Tennessee Valley Authority, 1101 Market Street, LP 5A, Chattanooga, Tennessee 37402-2801

**BELLEFONTE COMBINED LICENSE APPLICATION – RESPONSE TO REQUEST FOR  
ADDITIONAL INFORMATION – STABILITY OF SUBSURFACE MATERIALS AND  
FOUNDATIONS**

**NRC RAI NUMBER: 02.05.04-18**

**Figure 1. Effective foundation size of eccentrically loaded foundation (after Bowles, Figure 4-4)**

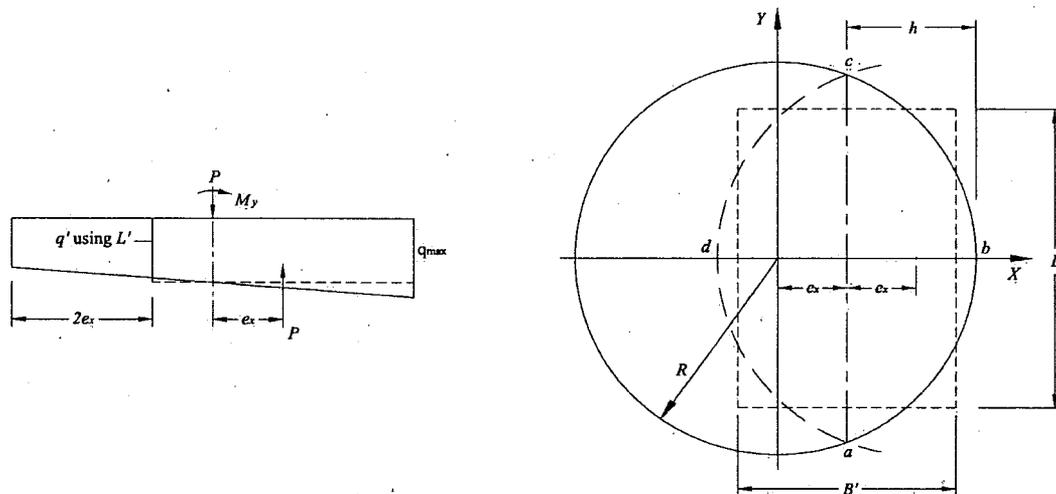
FSAR Section 2.5.4.10.1 states that the bearing capacity was evaluated for each Unit using two independent methods. Method 1 uses the ultimate bearing capacity of the Terzaghi approach based on the strength of the rock mass. Due to the finite dimension of the Bellefonte Nuclear (BLN) island designs, the Terzaghi equation originally developed for infinite base needs to be modified to incorporate the correction factor for parameters  $N_c$  and  $N_\gamma$  to take into account the footing finite geometry configuration, such as rectangular or circular, etc.. Furthermore, due to the non-symmetrical configuration of the footing of the nuclear island designs, the consequences of the eccentric loading need to be considered during the bearing capacity evaluation. Please explain whether the geometric correction factors were incorporated into your use of the Method 1 approach for the bearing capacity evaluation. If not, please update the bearing capacity values for the Method 1 approach with the correction factors. Please explain whether the effect of the eccentricity of the loading applied to the footing was considered for the bearing capacity investigation. If not, please update the bearing capacity analysis with the eccentric loading consideration.

The estimated area moment of Inertia ( $I_{xx}$ ) of the entire Nuclear Island foundation about the northeast-southwest axis is  $I_{xx} = 5.451E+07 \text{ ft}^4$ . Using this value for  $I_{xx}$  and solving for  $r_0$  gives  $r_0 = 91.3$  feet. Figure 1, adapted from Bowles (Bowles, J. E., Foundation Analysis and Design, 4<sup>th</sup> Edition, McGraw-Hill, Inc., 1988), describes a procedure for utilizing this circular area to compute an equivalent rectangular area subject to the eccentric loading.

Referring to Figure 1, the following nomenclature is used to simplify the equation for calculating the size and area:

The resulting equivalent rectangle is approximately 51.7 ft. by 146.7 ft.

Using this reduced width, the rock properties as described in FSAR Subsection 2.5.4.10.2, and a shape factor of 0.917 (calculated as described in section 1 above for a L/B of 3) results in a calculated ultimate bearing capacity of 368,000 psf, or a factor of safety of 10.5 with respect to the DCD Table 2-1 required value of 35,000 psf.
